# UNITED STATES PATENT AND TRADEMARK OFFICE

## Office Action Summary

10/702,294

## **DETAILED ACTION**

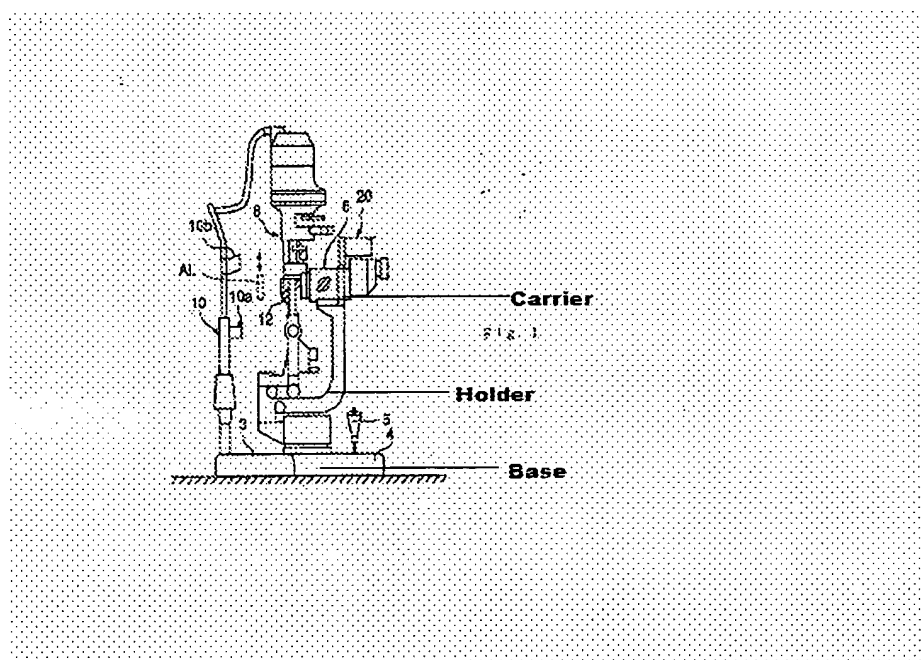
**12. Claims 1-4,7,11-15,17-19,22-25,28,32 are rejected under 35 U.S.C. 102(b) as being anticipated by Okamoto et al (US 2001/0028441). Okamoto et al teach an ophthalmologic apparatus which comprises of the following:**

**13. Re Claims 1 and 22:** Okamoto et al teach a device for viewing an eye of a patient, in particular a slit-lamp unit **See paragraph [0015,line 1-2]**, comprising viewing means **See paragraph [0014, line 7-8]** for viewing a front section of the eye and illuminating means **See paragraph [0016,line 1-9]** for illuminating the front section of the eye, characterized in that the illuminating means **See paragraph [0016,line 1-9]** are designed in such a way that it is also possible to illuminate a rear section of the eye **See paragraph [0016,line 1-9]**, and that the device comprises optical imaging means(**See Fig.2, AL**) for imaging the rear eye section, and an image acquisition device(**See Fig.2 unit 20**) for acquiring images of the eye with the aid of an image recording device(**See Fig 1, unit 43**), the image recording device being designed and capable of being positioned such that it is possible thereby to image the rear eye section without reflections ophthalmoscopically.

**14. Re Claims 2 and 23:** Okamoto et al teach that the illuminating means comprise a light source **See paragraph [0016,line 1-9]** for generating an illuminating beam **See paragraph [0016,line 1-9]**, and can be switched over from background illumination to foreground illumination. **See paragraph [0022].**

15. Re Claims 3,13 and 24: Okamoto et al teach that the image acquisition device comprises a deflecting device (**See Fig.2 unit 34**), it being possible to position the deflecting device in front of the eye such that a viewing beam emerging from the eye can be deflected through the image recording device. (**See Fig 1, unit 43**).

16. Re Claims 4, 14,15 and 25: Okamoto et al teach that the illuminating means comprise a light source and form a unit with the image acquisition device, it being possible to deflect a viewing beam generated by the light source onto the eye by the deflecting device (**See Fig 1,12**).

17. Re Claims 7,17,18,19, and 28 : Okamoto et al teach that the image acquisition device comprises a holder with a base and a carrier, the image recording device being fastened on the carrier, the base being connected moveably to the device, and the holder having guide means for displacing the carrier relative to the base. (**See Fig.1**)
